ATLANTIC PILOTAGE AUTHORITY

HERRING COVE BREAKWATER REPLACEMENT

CONTRACT NO. 190248.00

ADDENDUM NO. 1

DRAWING S02 NEW BREAKWATER PLAN AND SECTIONS

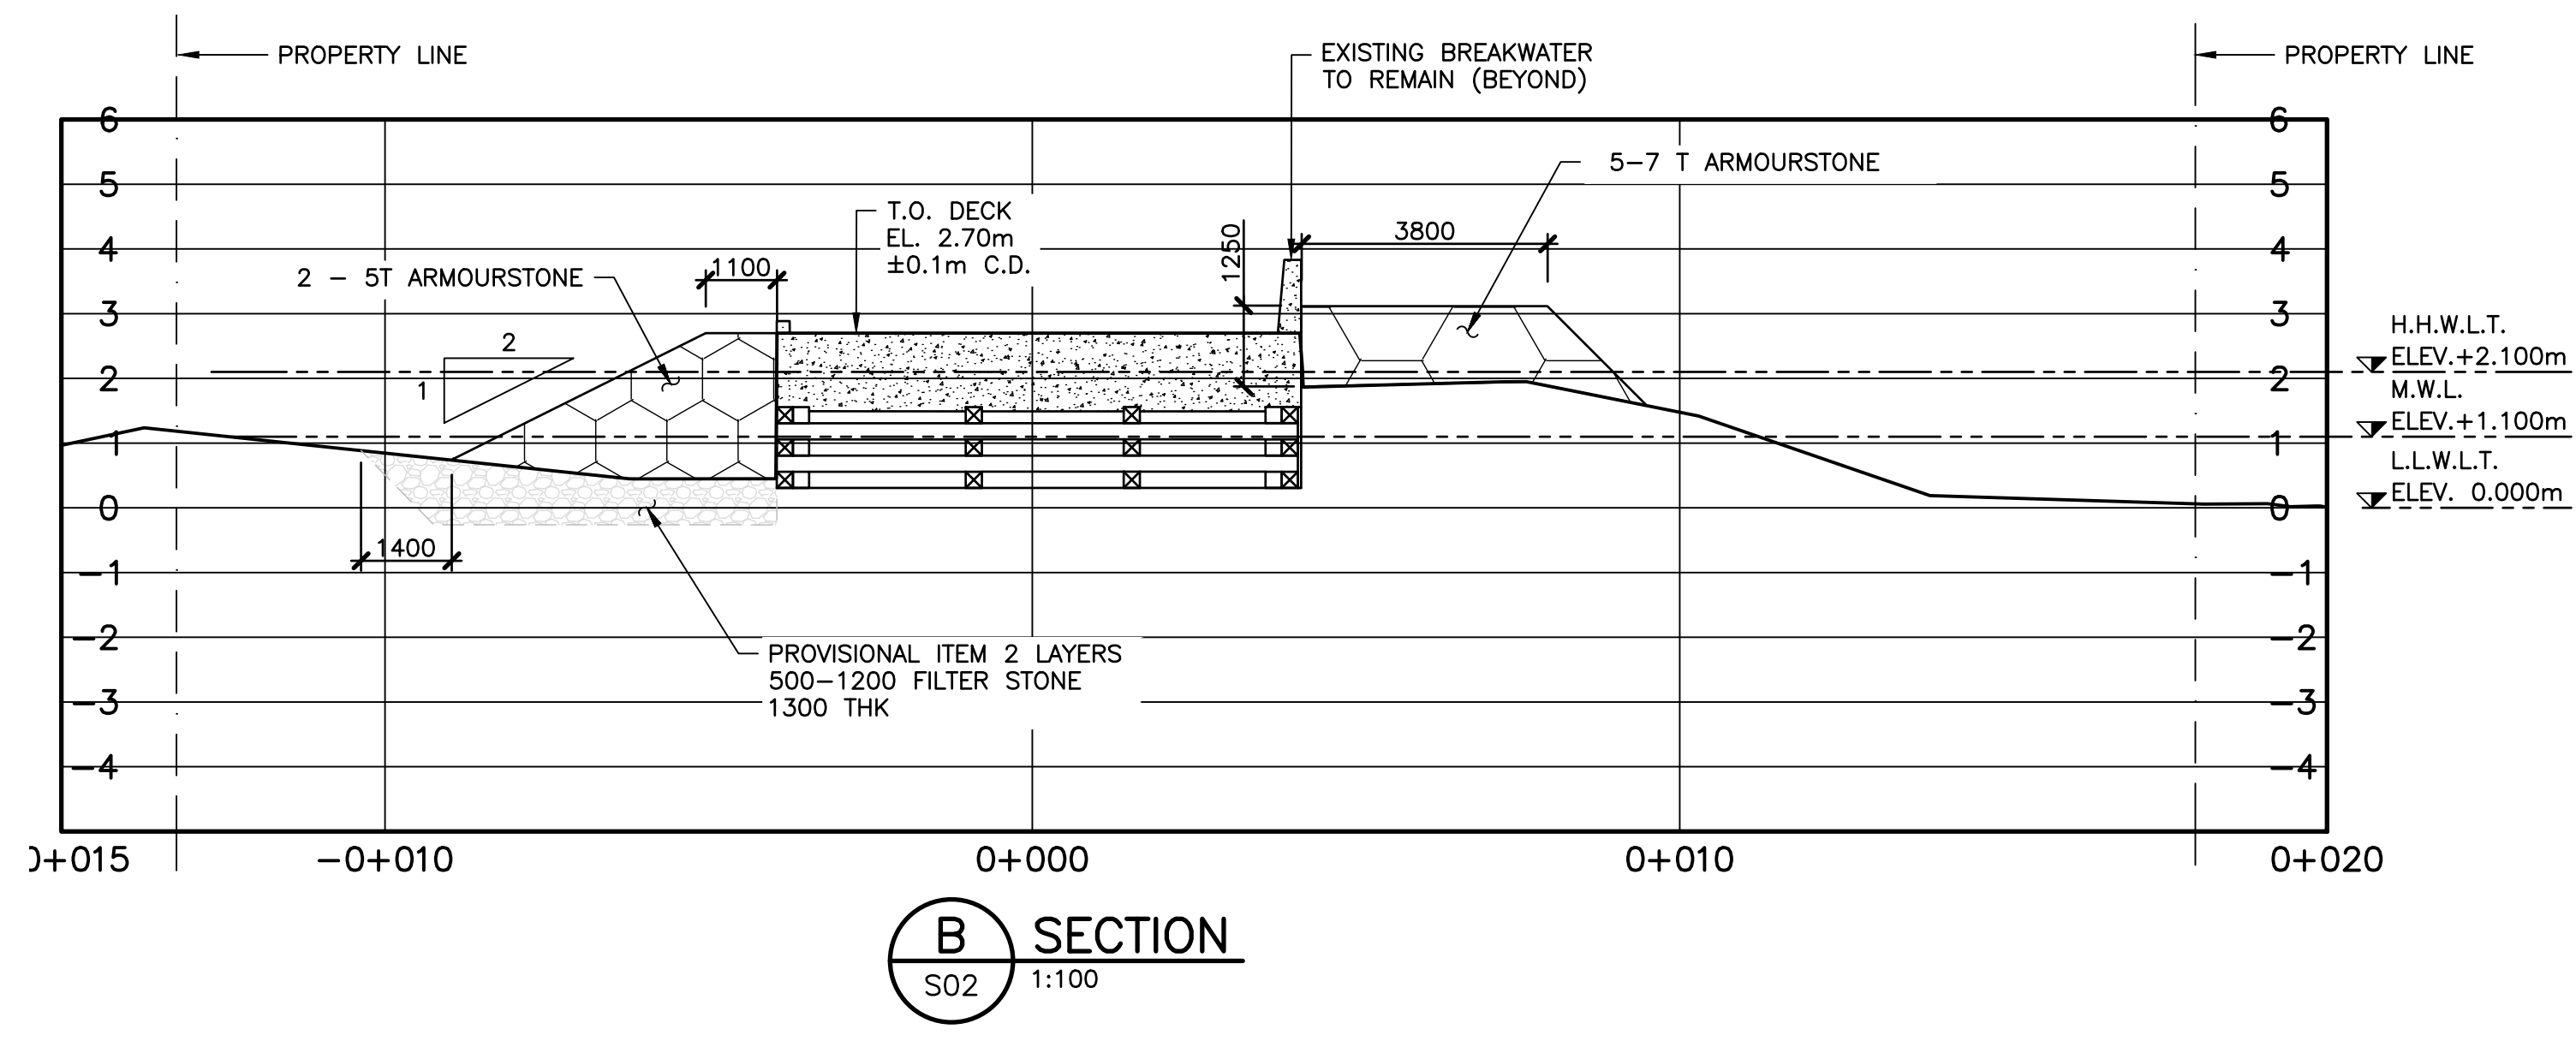
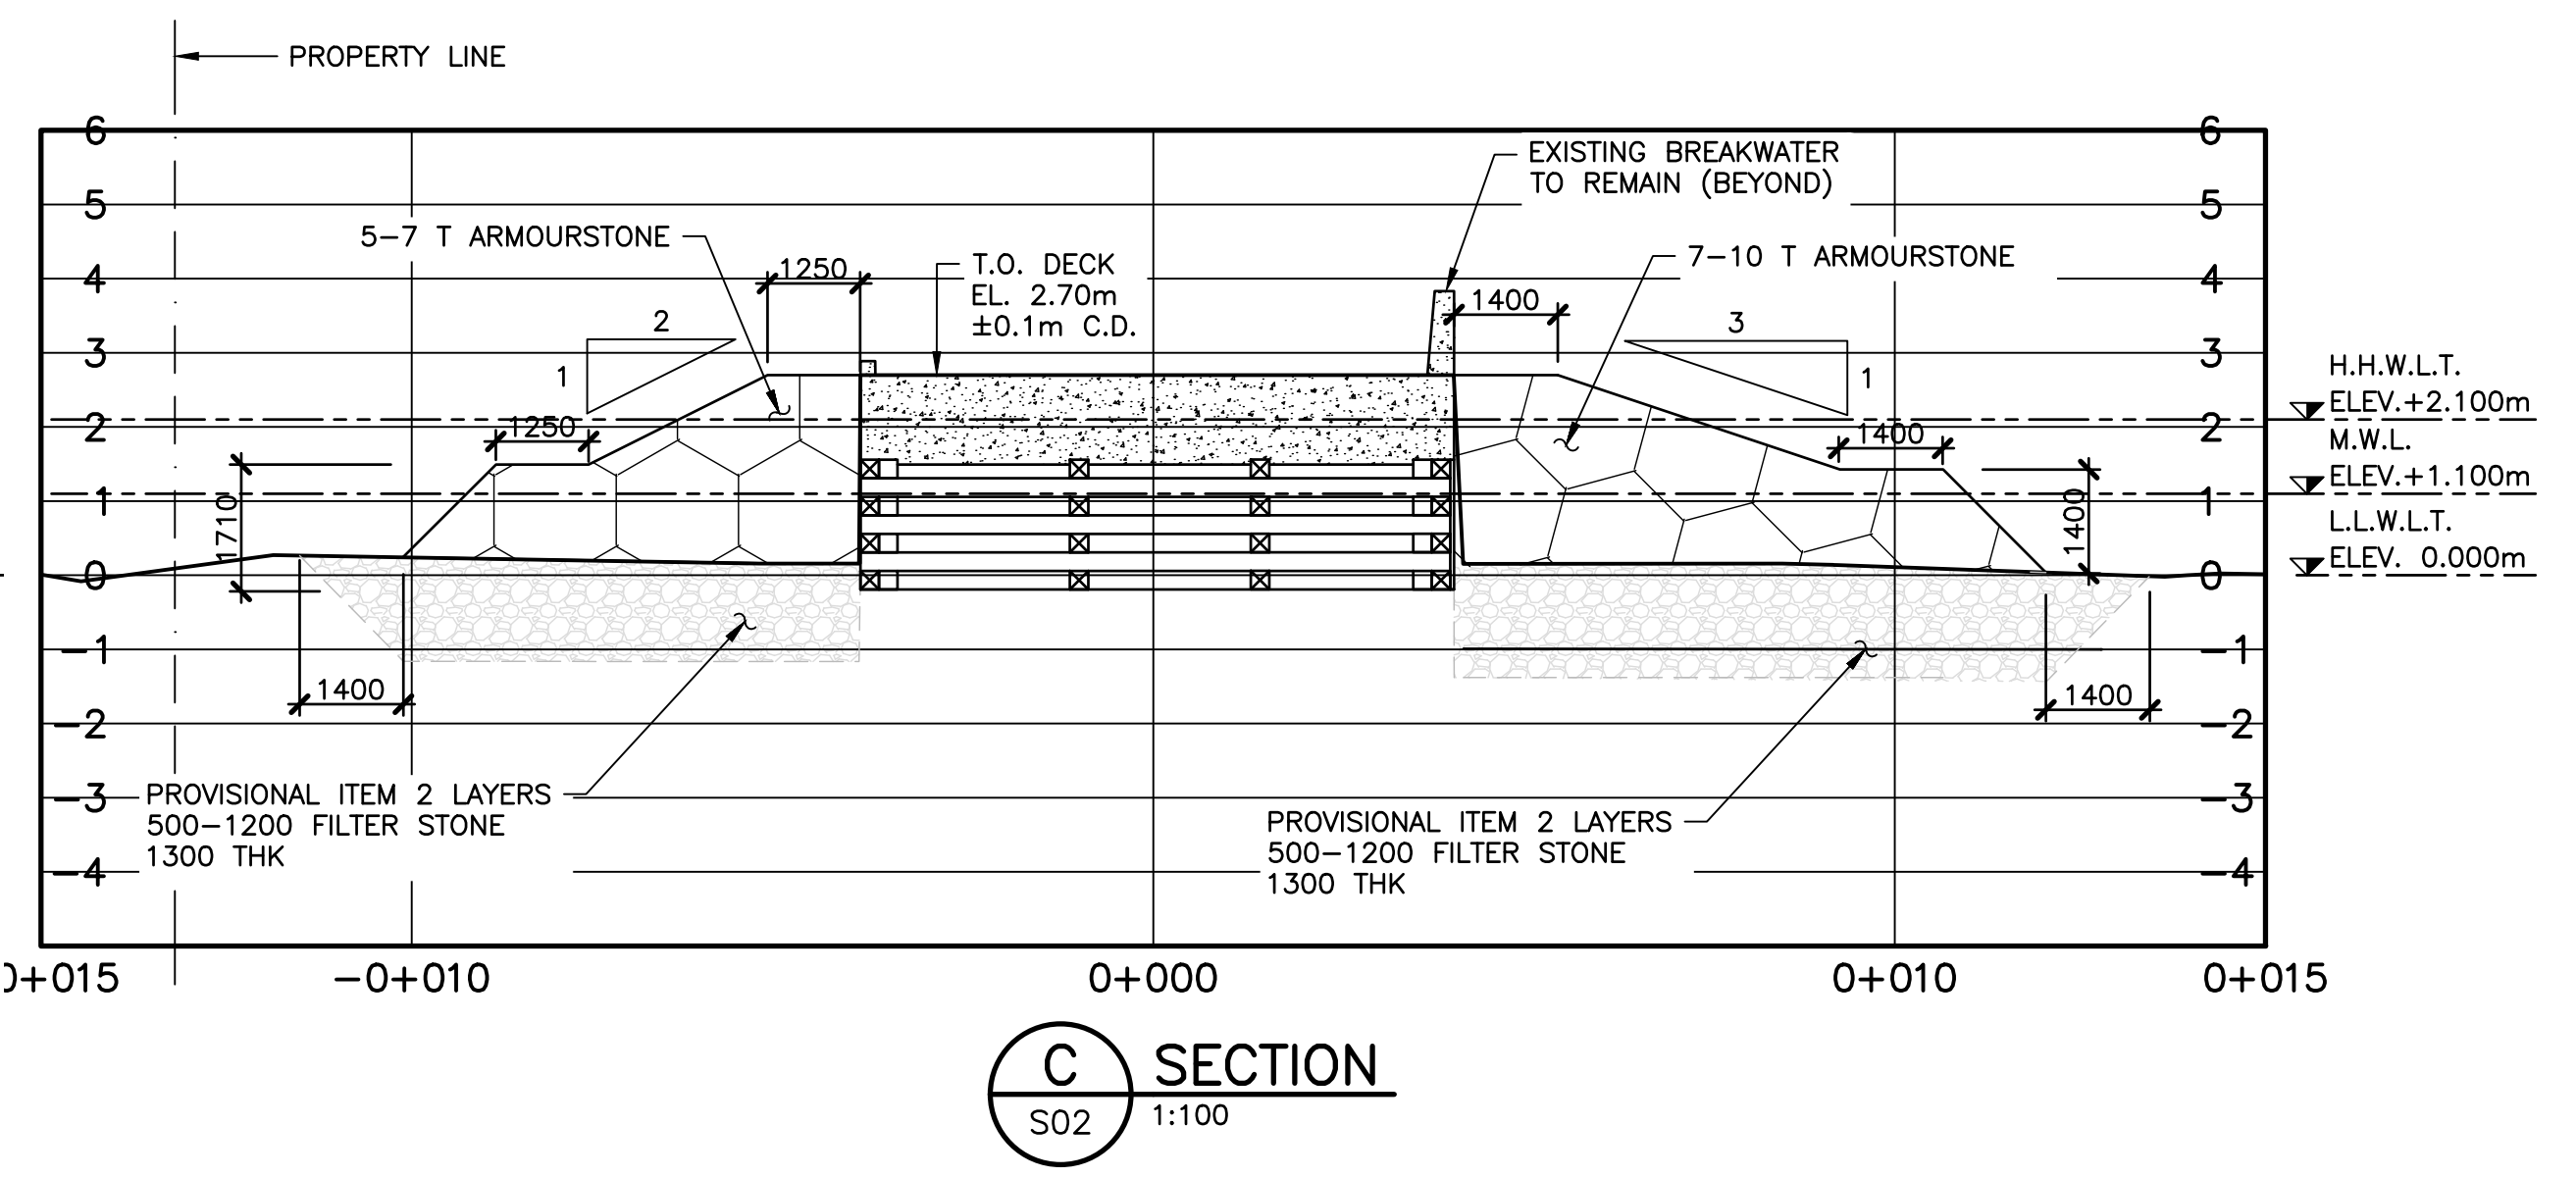
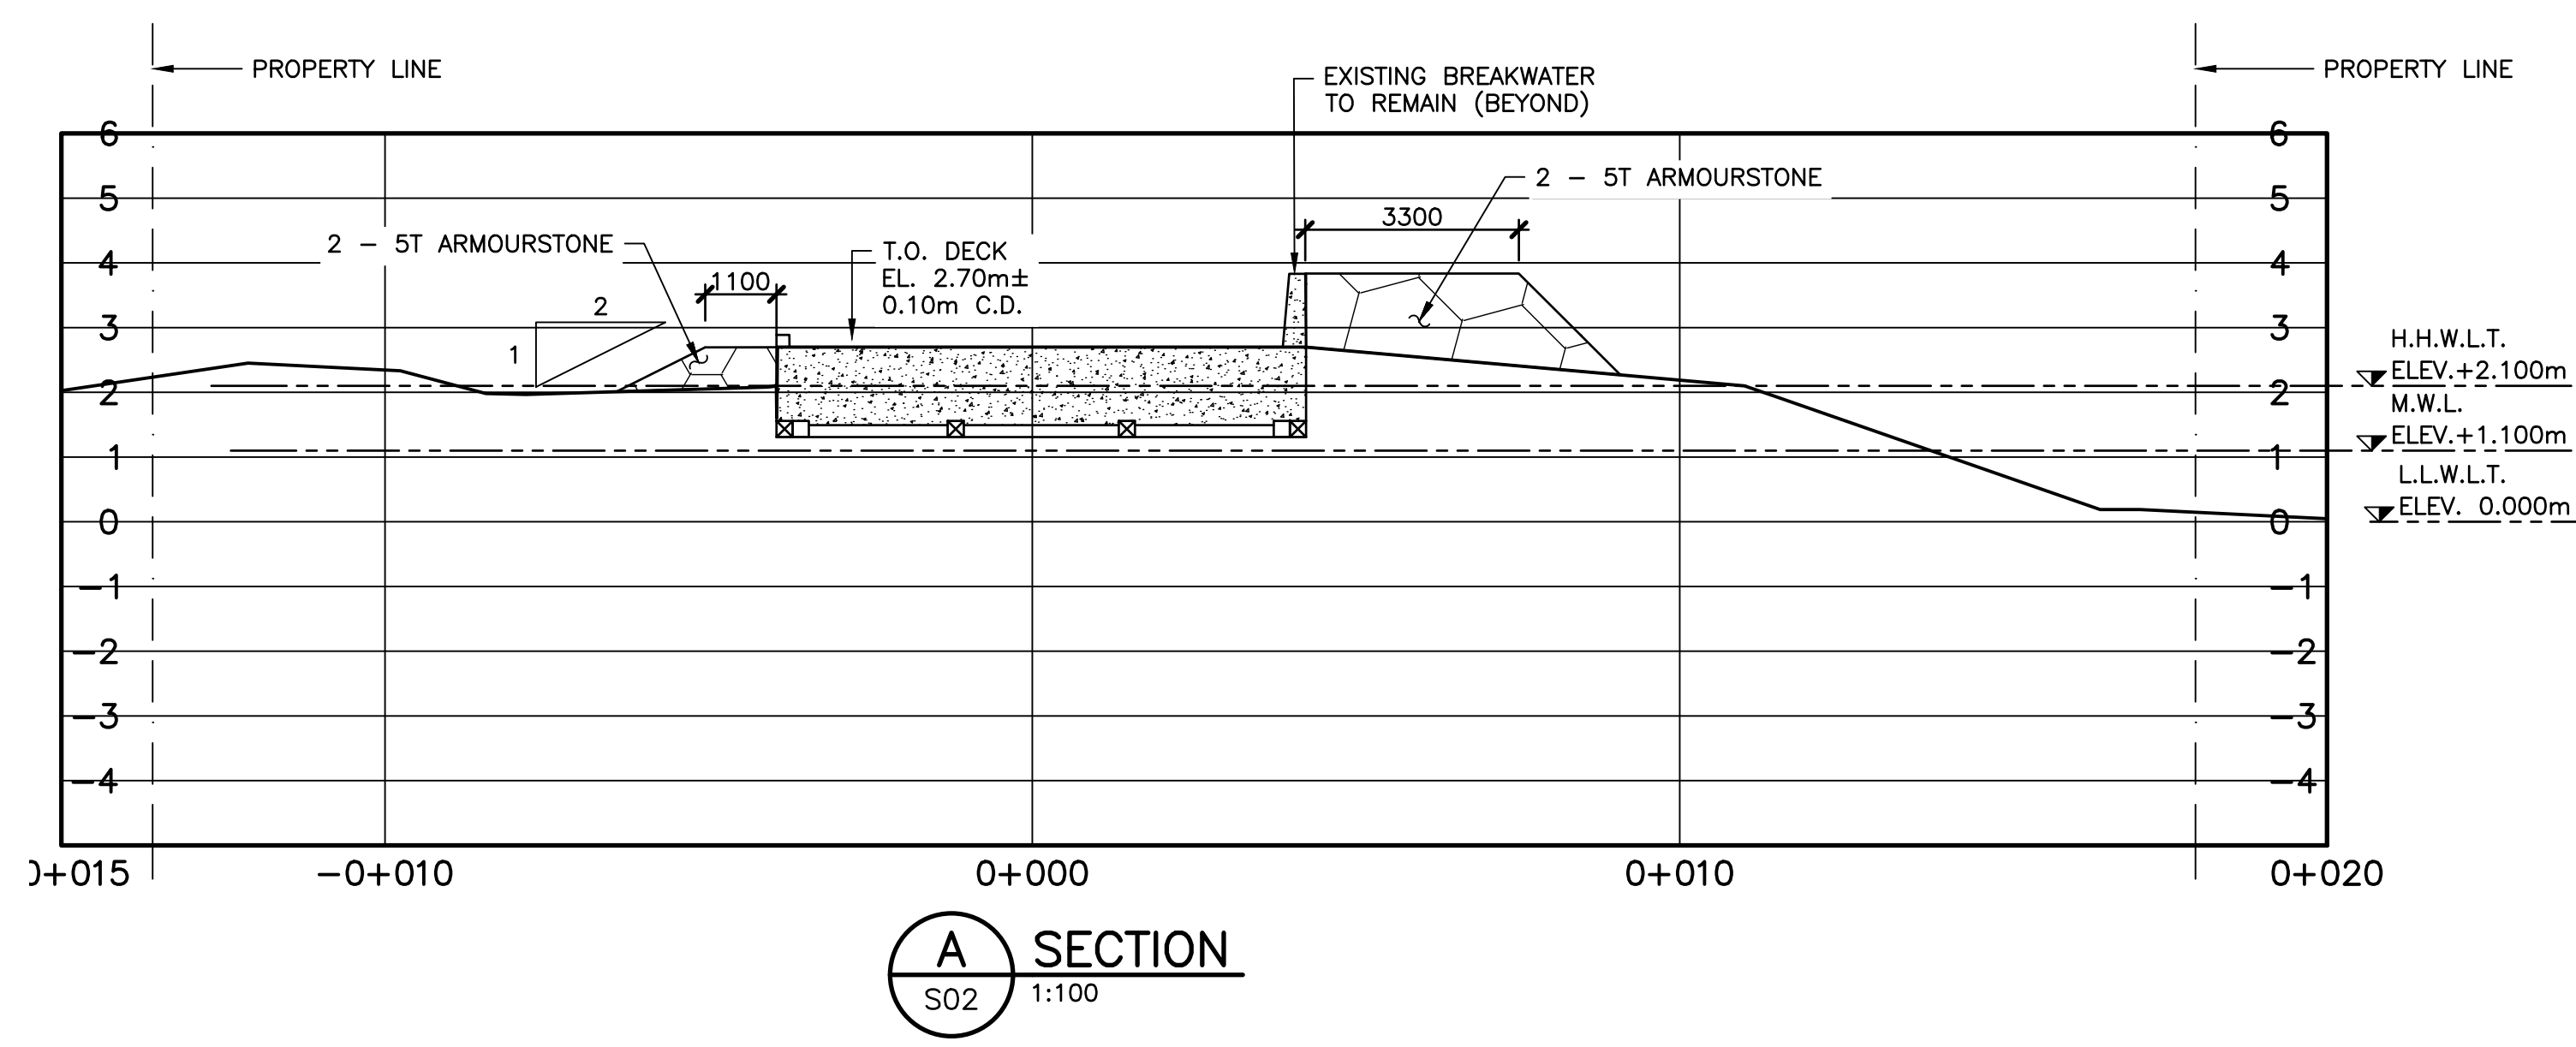
Replace with attached Drawing S02 – NEW BREAKWATER PLAN AND SECTION, elevation marks added to plan contours, Re-Issued for Tender, dated Feb. 28/20.
